Comment i-451 (145B, P267, L7)

Figure 145B-6A-PSE implementing CC_DET_SEQ=1, do_cxn_chk result is dual, staggered detection

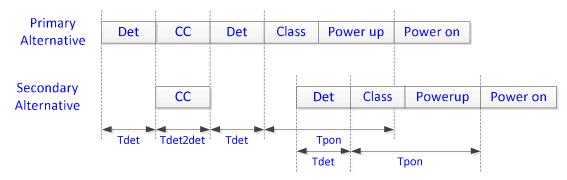
Figure 145B-6 for the staggered option for the dual signature for CC_DET_SEQ=1, shows that for the second alternative, DETECTION starts only after the Power up of the primary alternative which is OK but not limited just to this use case. The detection can start also after the detection of the primary alternative as shown by the state machine. We need show it by additional drawing (145-6A), or drawing that shows all possibilities.

Add the following drawing (Figure 145B-6A) after Figure 145B-6.
